300 Somme Street, Ottawa, ON

Servicing and Stormwater Management Report

May 27, 2020
Revised: Nov. 9, 2020

Please find enclosed the 'Servicing and Stormwater Management Report', revised November 9, 2020 for the above noted project. The report outlines the detailed servicing and stormwater management design to meet the requirements of the City of Ottawa and South Nation Conservation Authority (SNCA) in support of a Site Plan Control application and is submitted for your review and approval. This report has been revised in response to City of Ottawa comments dated July 29, 2020 and South Nation Conservation Authority dated July 20, 2020. The comment letters and responses are included in Appendix G.

Copart Facility – 300 Somme Street (119181)
Figure 1 – Proposed Land Use / SCS Curve Number (CN) Parameters

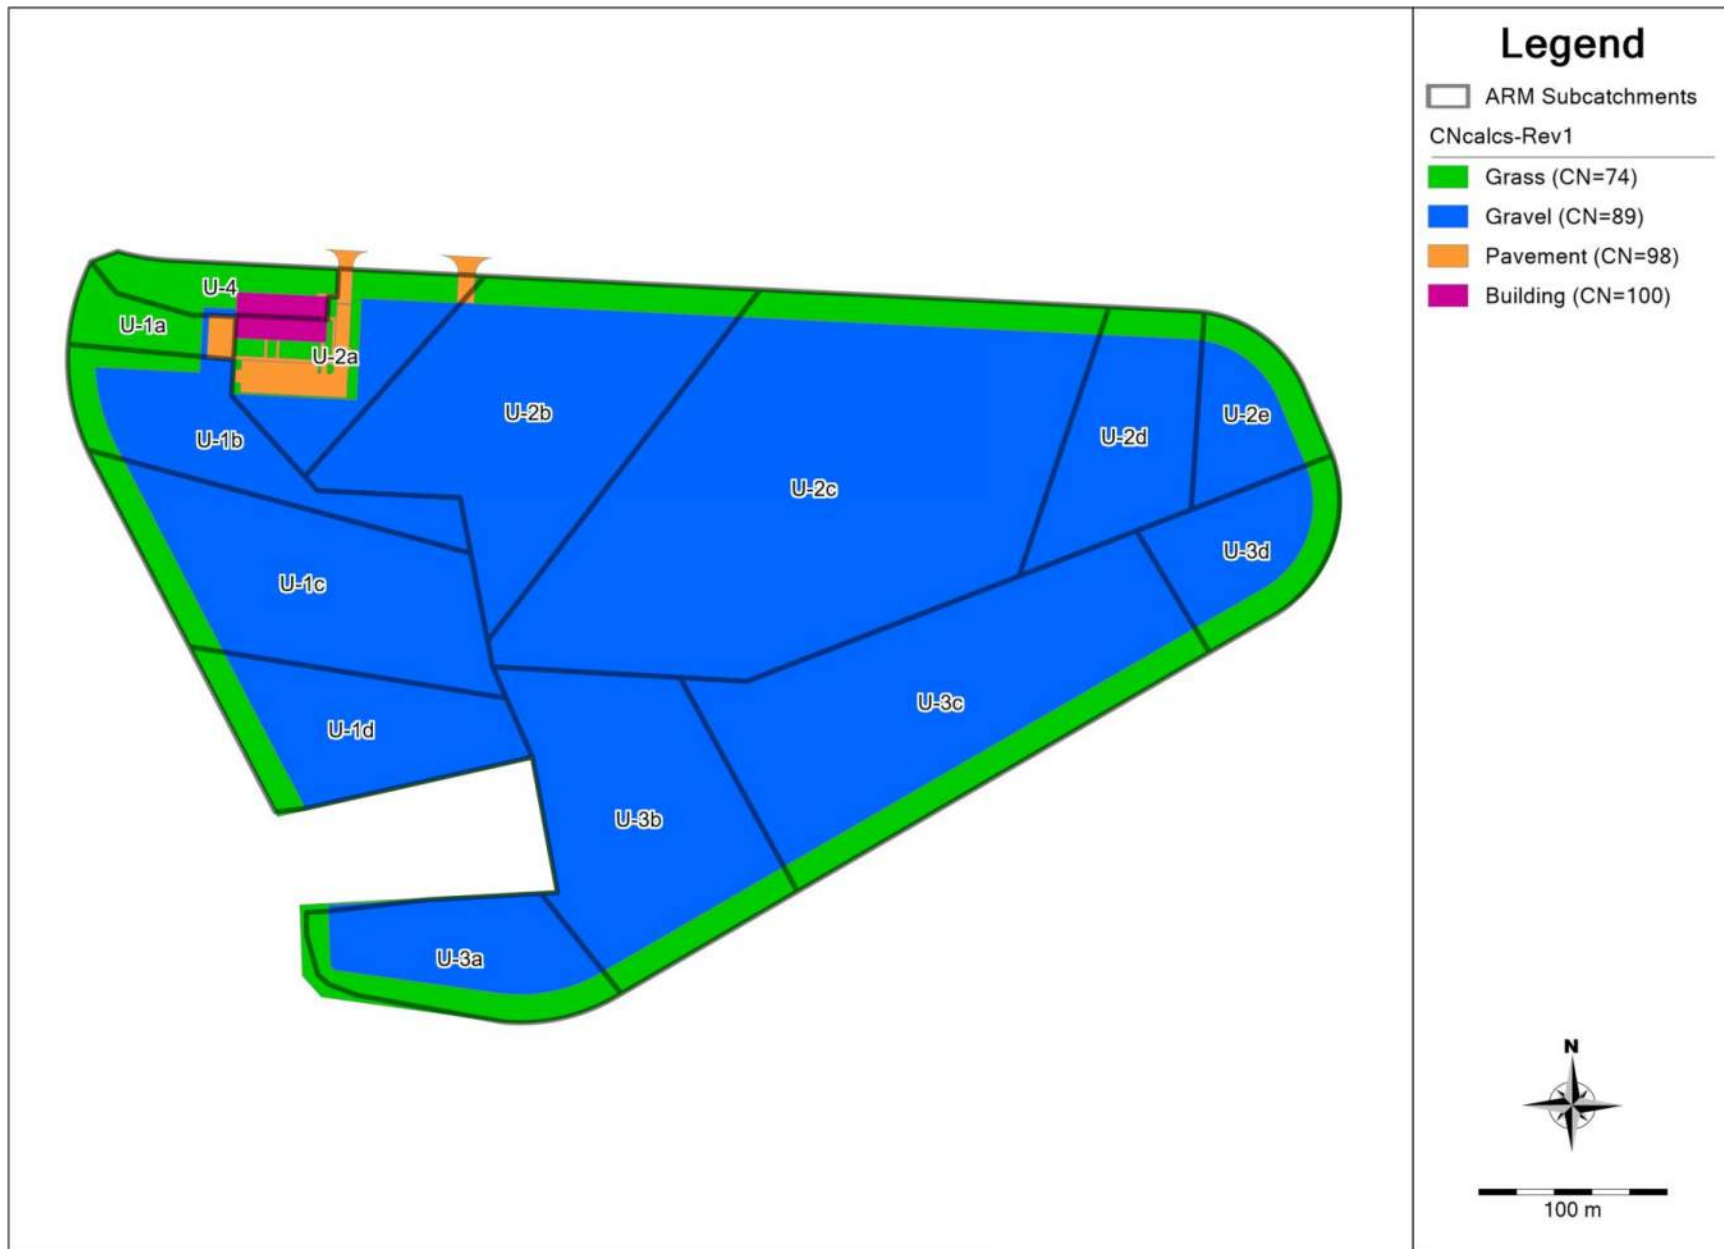
5. *It is noted that the report uses the “NASH” command to calculate flows. Typically, areas with imperviousness values greater than 20% use the “STAND” command. Review and revise accordingly.*

The SWM analysis utilized the NASH Instantaneous Unit Hydrograph (IUH) approach based on the SCS Curve Number (CN) Method to transform rainfall to runoff. This methodology is suitable for runoff conditions that predominantly consists of sheet drainage and open channels.

For the Copart Facility, the CN values were estimated by area-weighting the reference CN values shown in Table 1. The layout of the proposed land uses / SCS Curve Number parameters that were used to area-weight the CN values for each subcatchment are attached (Figure 1).

The NASH IUH was used in the SWM analysis as the SCS Curve Number method better represents the parameters of the predominantly compacted gravel land use versus dividing the land use into equivalent impervious and pervious areas (i.e. STANDHYD).

The actual impervious areas of the proposed development (shown in Figure 1) consist of 2% of the total area. This is less than the recommended 20% imperviousness threshold for using the STANDHYD routines.
